Title of Report:	Planning Committee Report – LA01/2024/0170/O
Committee Report Submitted To:	Planning Committee
Date of Meeting:	27th November 2024
For Decision or For Information	For Decision – Referred Application by Alderman John McAuley

No: LA01/2024/0170/O **Ward:** Rasharkin

Address: Approximately 35m South West of 344 Craigs Road Rasharkin

Proposal: Proposed Infill Dwelling and Garage

Site location Map

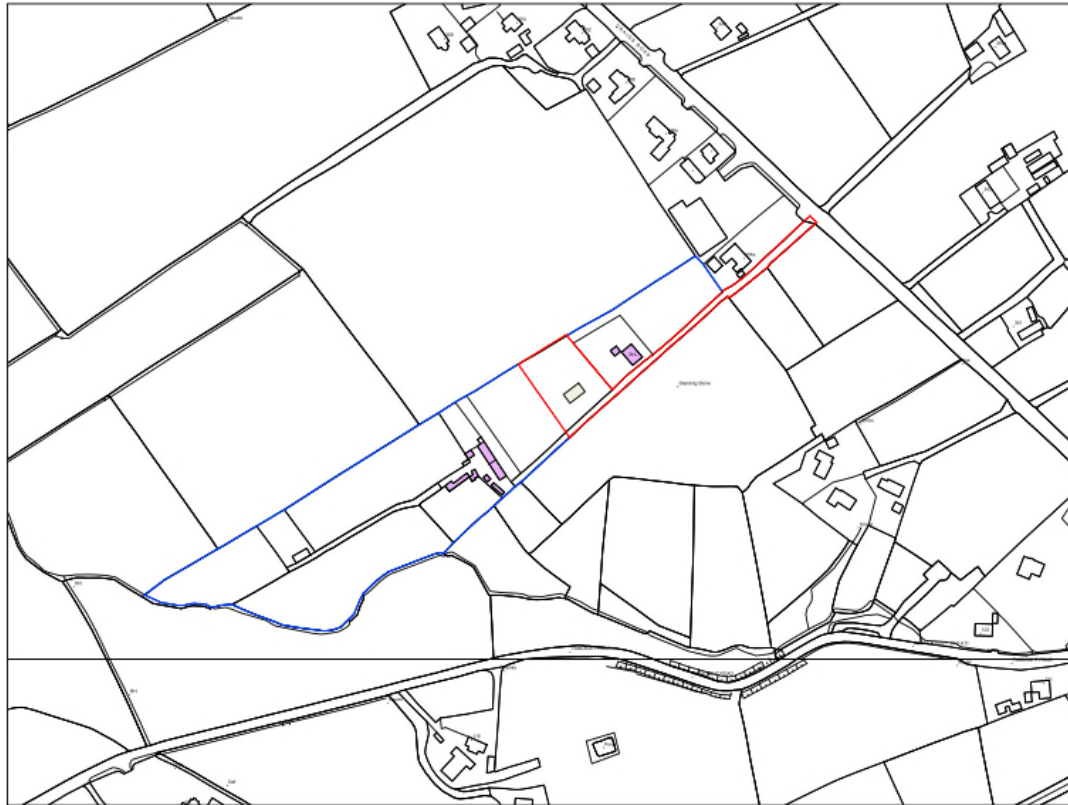
- 7.6 It is considered there is not a substantial and continuously built up frontage along this laneway. No. 344 Craigs Road is the only dwelling with a frontage to the lane. As per the case officers site visit, and from the OS maps, it is clear that the laneway terminates once it reaches the buildings to the far south west of the site. This plot and associated buildings are accessed from the laneway but do not have a frontage to the laneway. It is not accepted that the laneway runs through this plot as it is within the defined private curtilage.

- 7.8 The policy also requires the gap site to be small in that a maximum of two dwellings could be accommodated within the resulting gap. The Justification and Amplification text at Paragraph 5.34 is clear that the gap site must be between houses or other buildings. The guidance in Building on Tradition indicates that when the gap is more than twice the length of the average plot width, it is often unsuitable for infill with two new plots. The gap between No 344 Craigs Road and the dwelling/buildings to the south west measures 117metres.

- 7.9 The plot width of No. 344 Craigs Road measures 28.2metres while the plot further south west has a plot frontage of the site measures 15.1metres or if measured vertically, 42.4metres. The average plot frontage is therefore 21.65metres or 35.3 (depending on which way the width is interpreted for the plot to the south west). Nonetheless, it is considered the gap of 117metres could accommodate more than 2 dwellings while respecting the existing plot sizes in accordance with CTY8.

- 7.10 It is considered there is not a substantial and continuously built up frontage along this laneway and the gap is too large to accommodate a maximum of two houses whilst respecting the existing development pattern along the frontage in terms of size, scale, siting and plot size and therefore fails policy CTY8.

- The predominant reason for refusal relates to the principle of ribbon development and the proposals adherence to this. Paragraph 5.33 of PPS21 clearly states that “Buildings sited back, staggered or at angles and with gaps between them can still represent ribbon development, if they have a common frontage or they are visually linked.” Appeal 2021/A0094 was raised with the planning department but they have dismissed the precedent set within this as the garage at no.344 craigs road is not large. However, the garage on the appeal site was also not large, a single bay garage. It is my opinion that the proposal and the appeal are identical in these terms in that whilst it is a small garage, it is visible from the laneway and clearly detached from the dwelling at no.344 Craigs Road. This would mean that the dwelling at no.344 craigs road and the garage count as two buildings towards the 3. The final building is the old detached farm house to the south west. The planning department have stated that the farm house accesses off the lane and does not front it, though it could be argued that the lane extends through the farm and travels for a further couple of fields. This would mean that there are 3 buildings which represent a ribbon of development and would comply with this element of the policy.

- The second element of CTY8 is respecting the ribbon in terms of frontage, plot size etc. the frontage length of no.344 craigs road is larger than previously stated as the curtilage was extended under a previous application, which would mean the gap can only accommodate 2 houses in the gap between buildings and not 3, making it comply with policy CTY8
